**STATUS OF FEMP WASTEWATER TREATMENT UNITS AS SWMUS OR  
HWMUS - (USED AS A REFERENCE IN OU1 RI)**

**C:OP:93-0737  
DOE/FERMCO    OEPA  
28  
LETTER**

**STATUS OF FEMP WASTEWATER TREATMENT UNITS AS SWMUs OR HWMUs**

ENCLOSURE 2  
RESPONSE TO SPECIFIC OEPA COMMENTS ON THE DRAFT REPORT ON FEMP'S WWTS

**Attachment 1**  
**Block Flow Diagrams for the FEMP Wastewater Treatment System**  
**(1980 to 1990)**

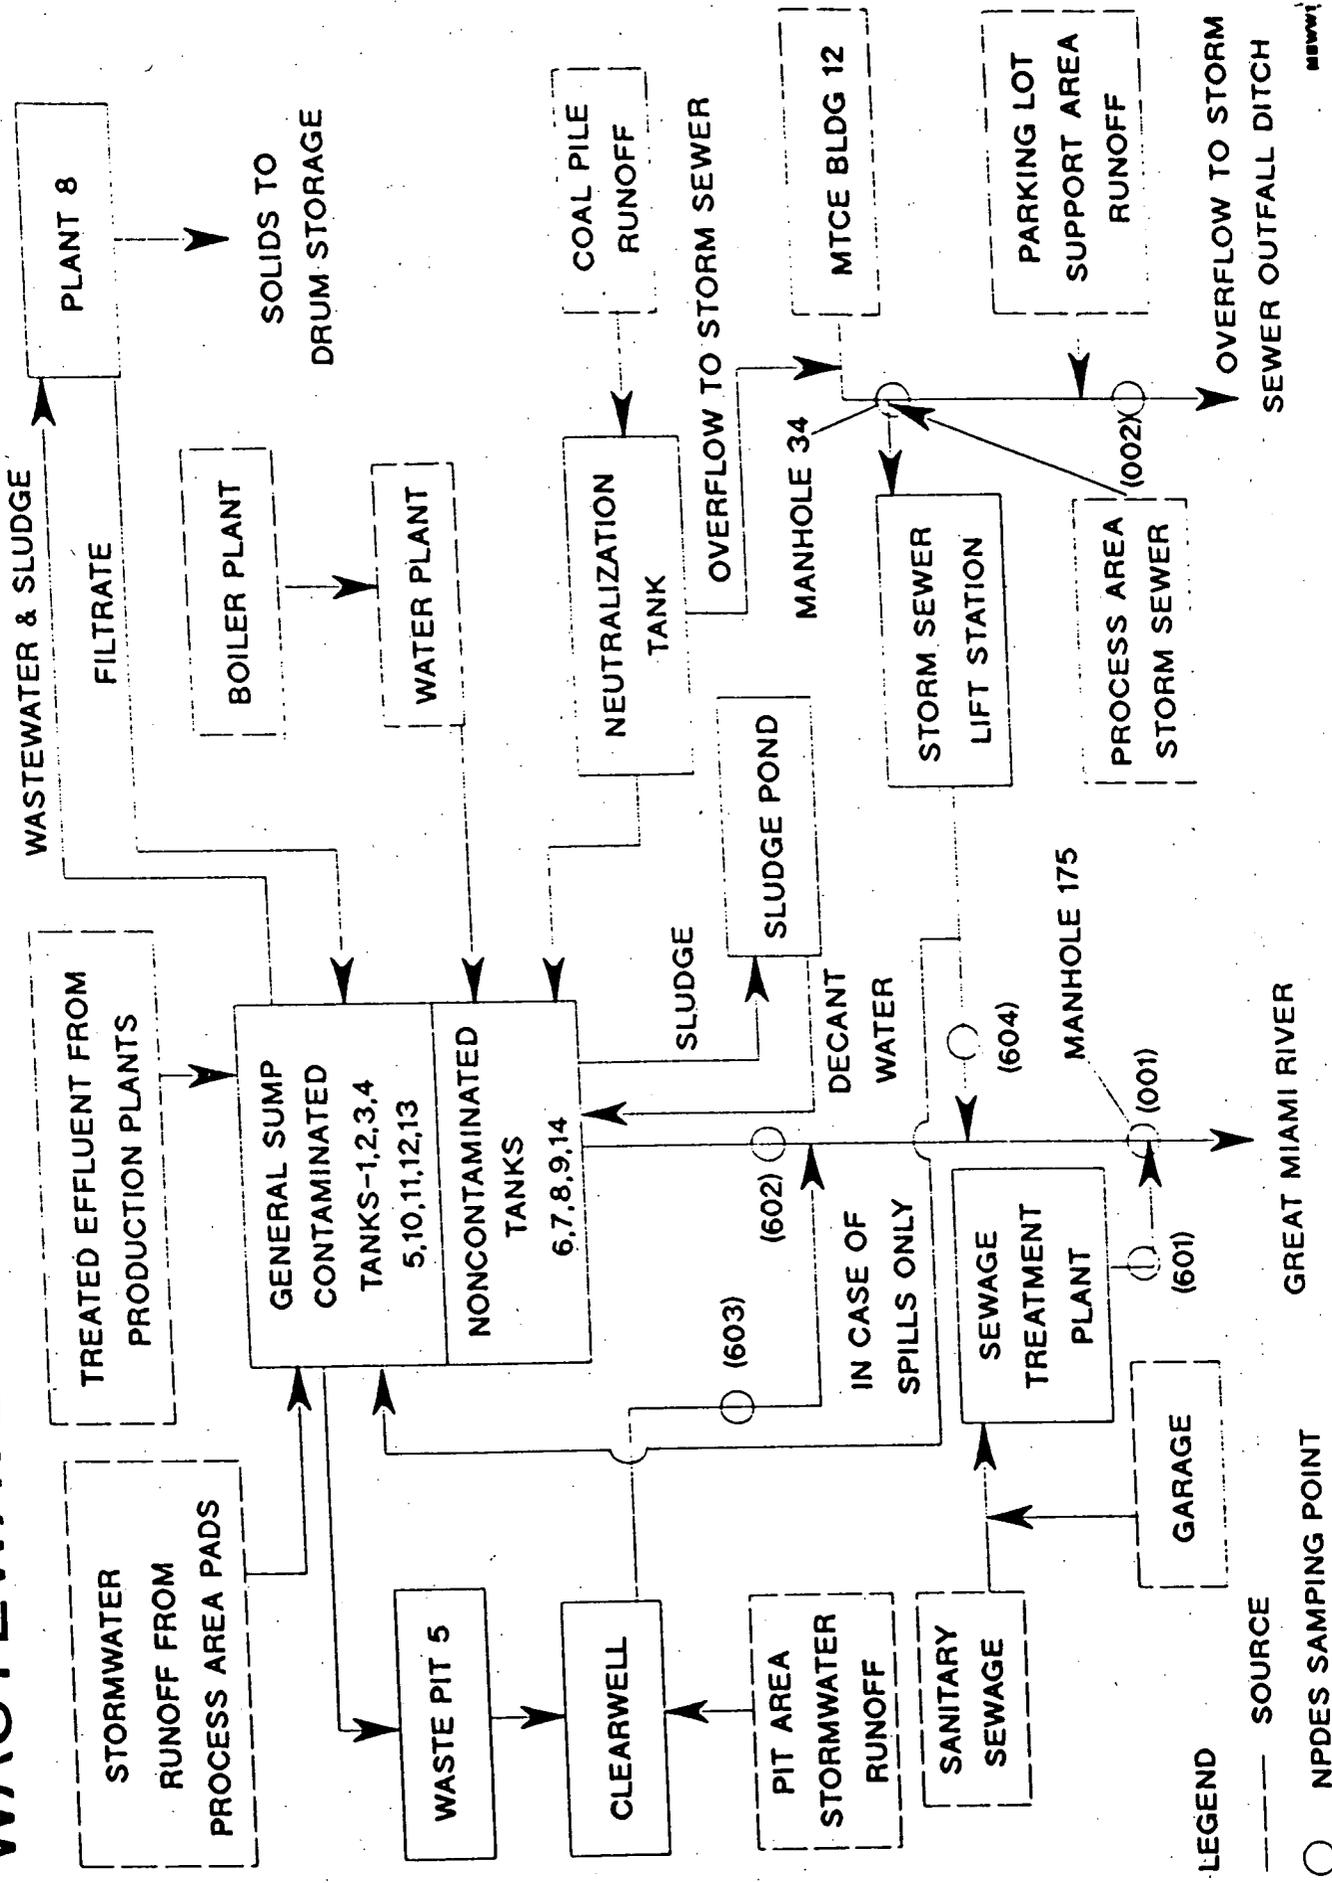
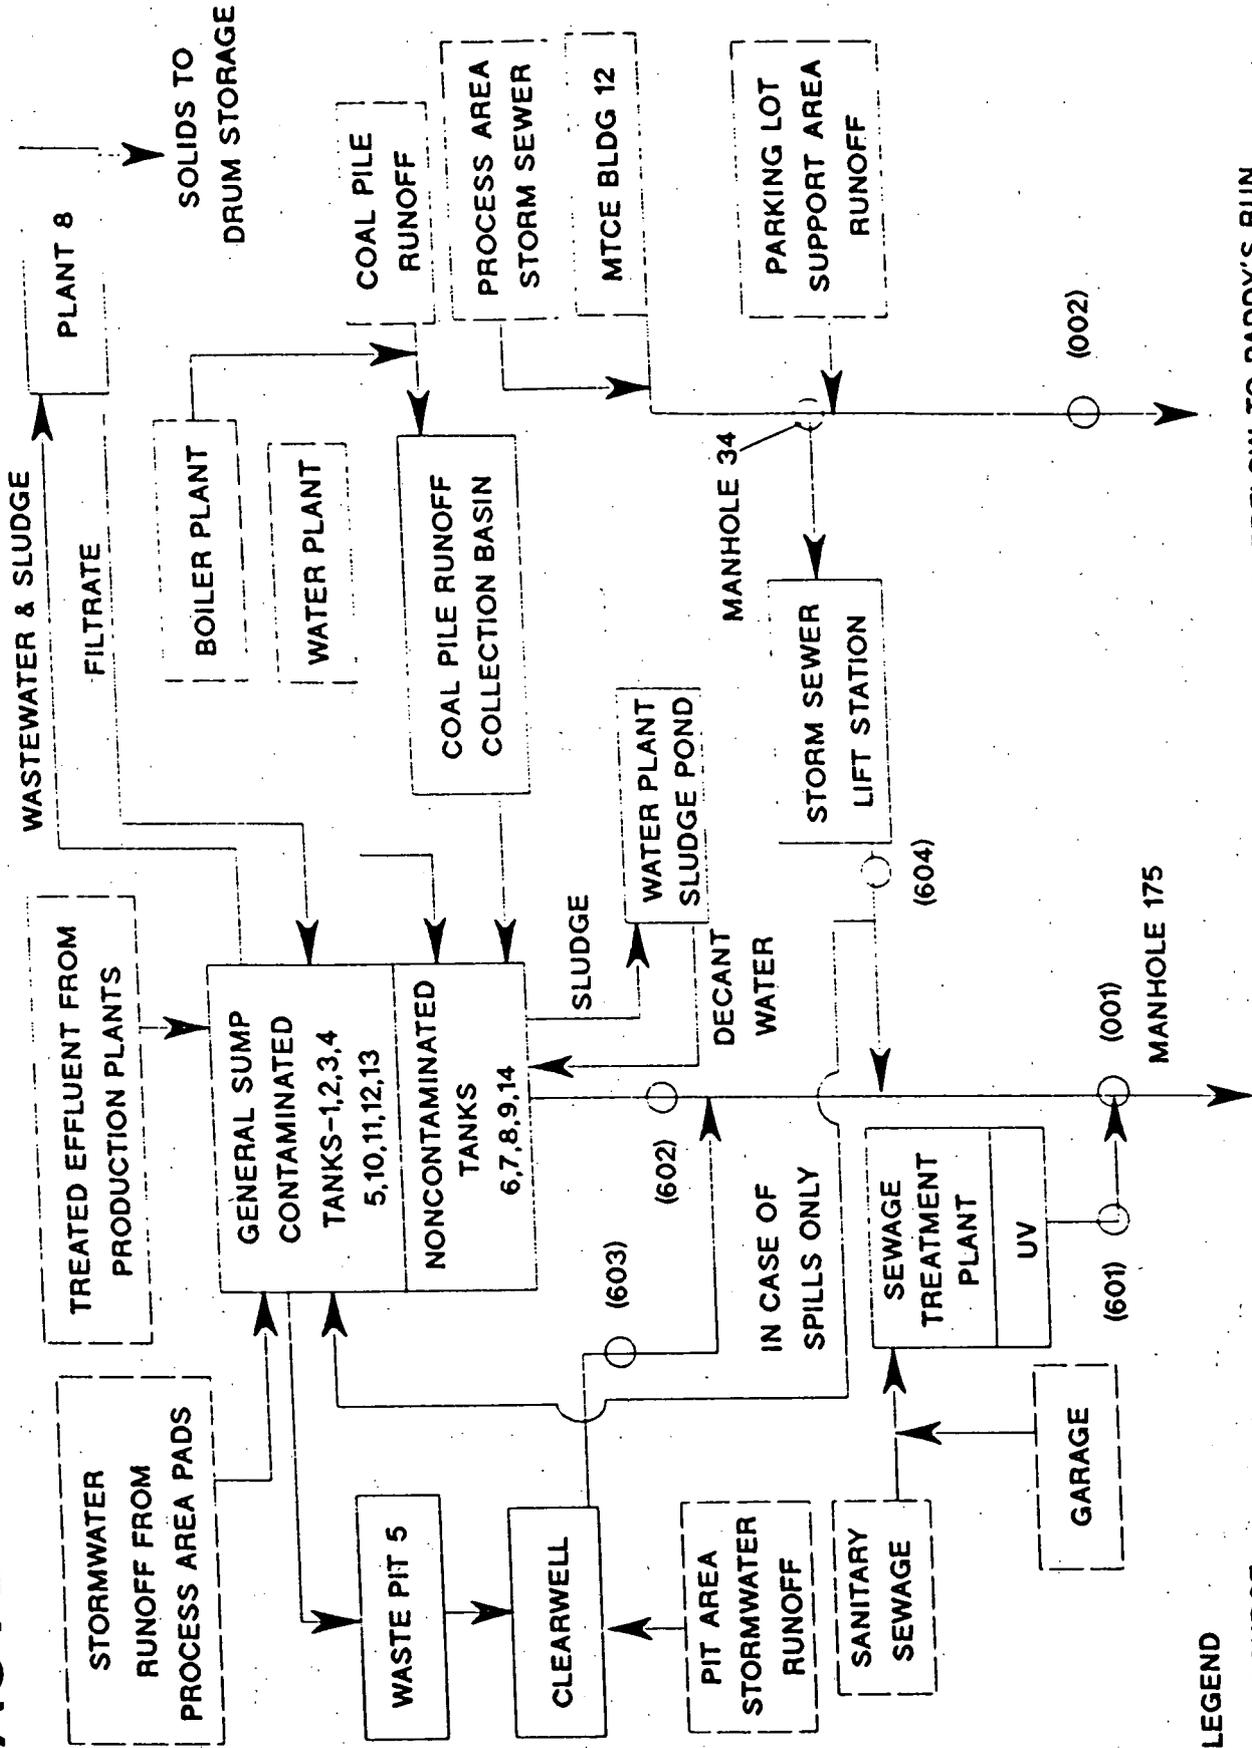
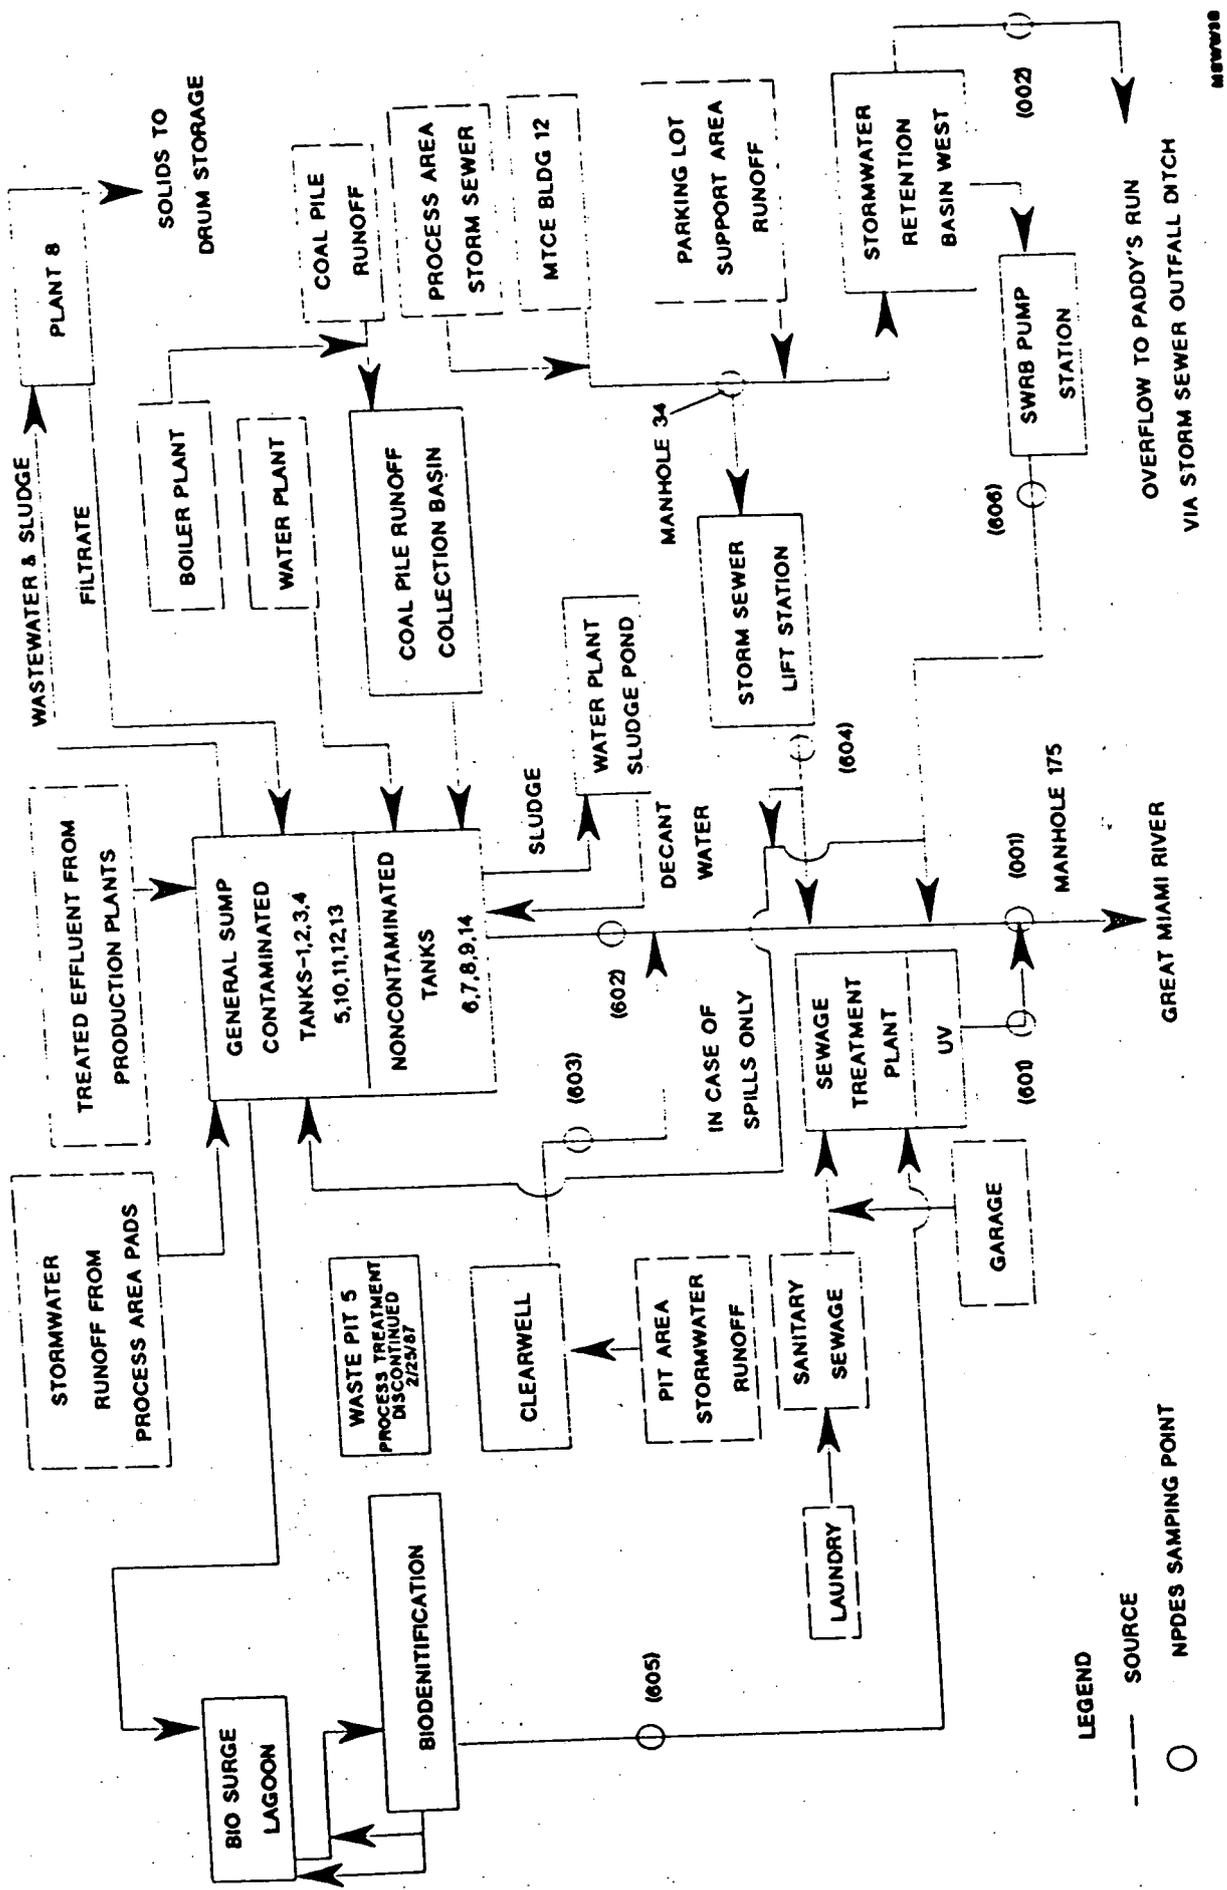
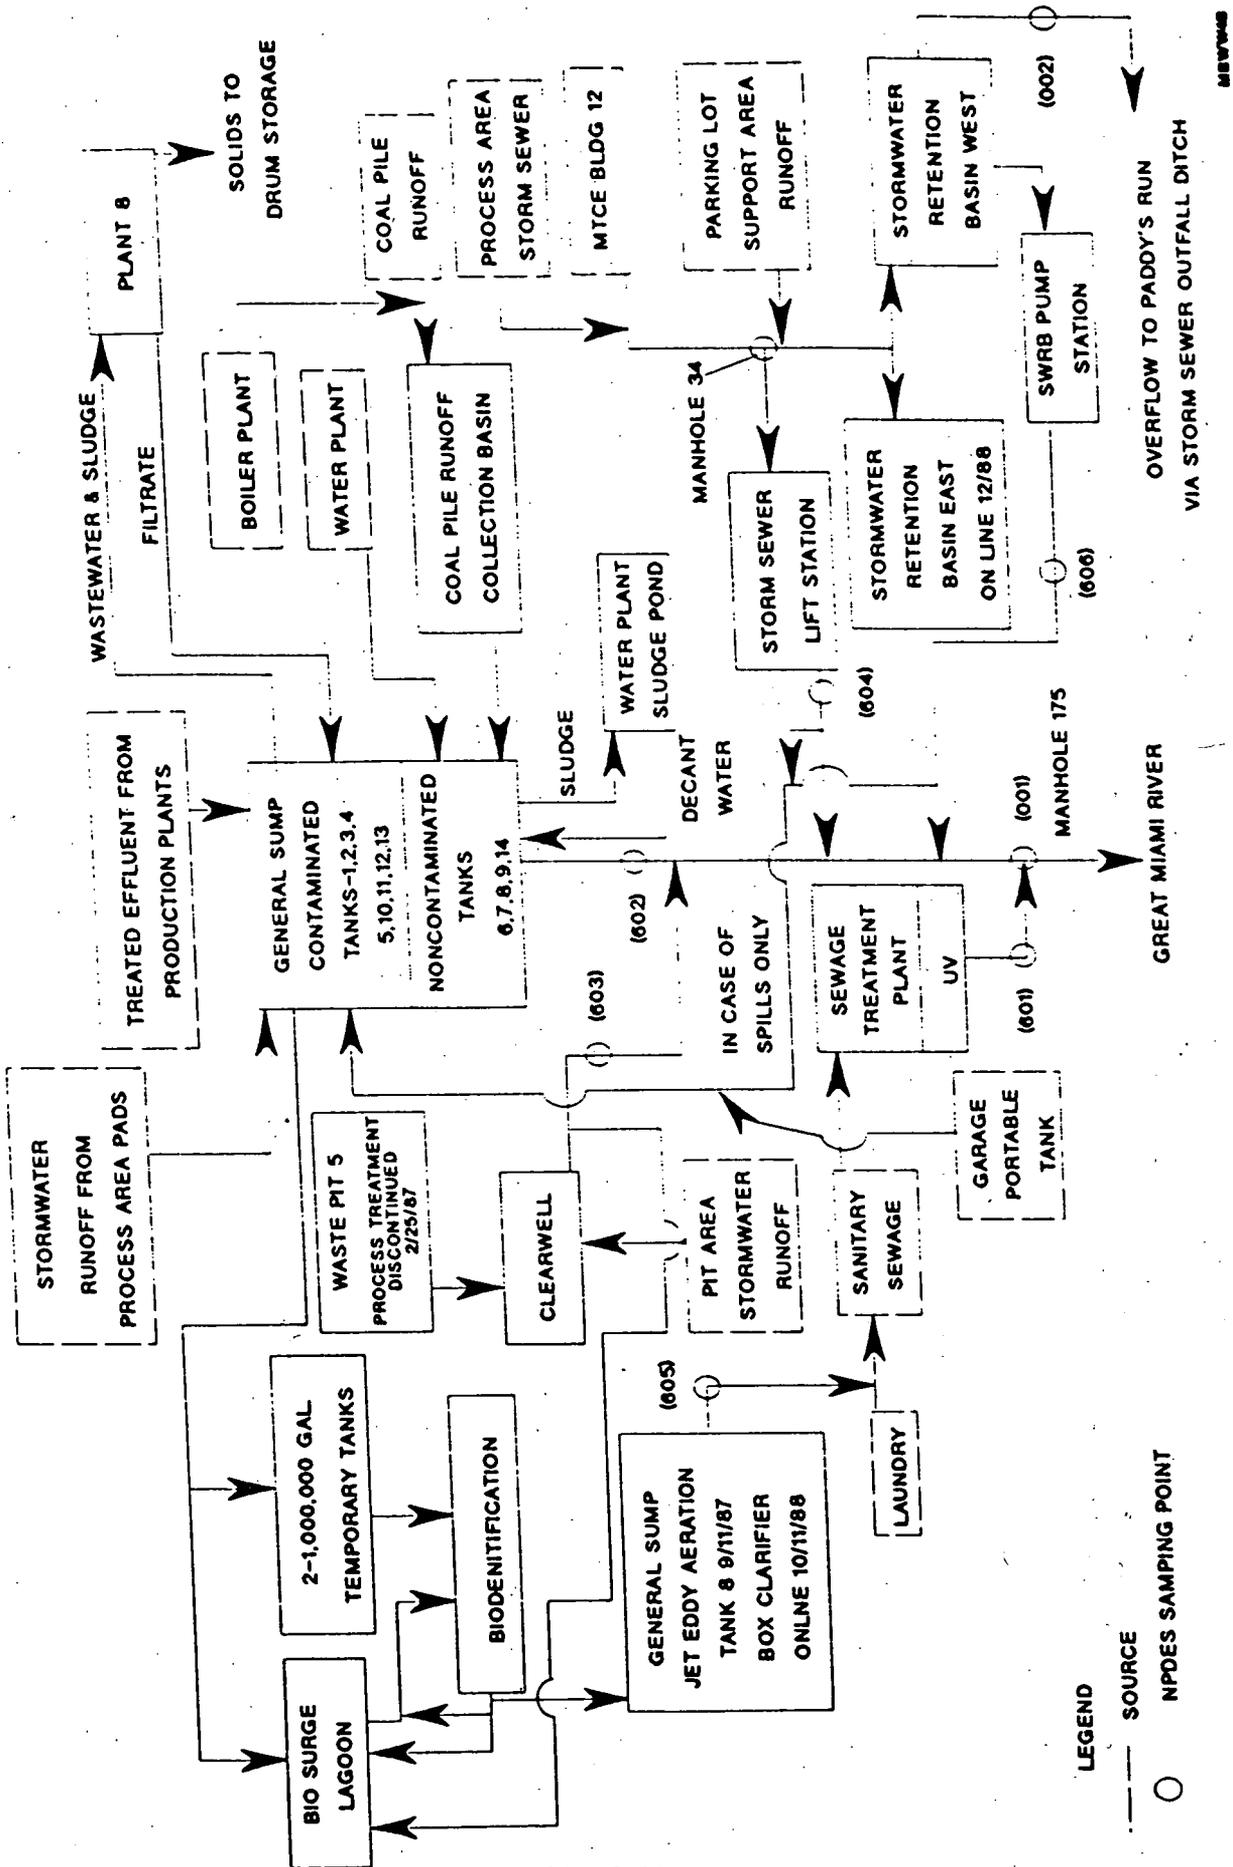
1. *Ohio EPA requests all documentation which exists to support the numbers used for wastewater flow in the 9/5/91 report for the NGS headworks calculations. Indicate any and all locations at which this flow was measured.*

The final wastewater mixture rule exclusion report uses the National Pollutant Discharge Elimination System (NPDES) Discharge Monitoring Report (DMR) data for all flows used in the calculations. The NPDES permit requires flow measurement at the final outfall 001 and the internal outfalls:

- Sanitary System - Sampling Point 601
- Noncontaminated General Sump - Sampling Point 602
- Contaminated General Sump - Sampling Point 603 (prior to 1987)
- Stormwater System - Sampling Point 604

The block flow diagrams in Attachment 1 show the location of these sampling points. A summary of the data is provided in Table 4 of the report.
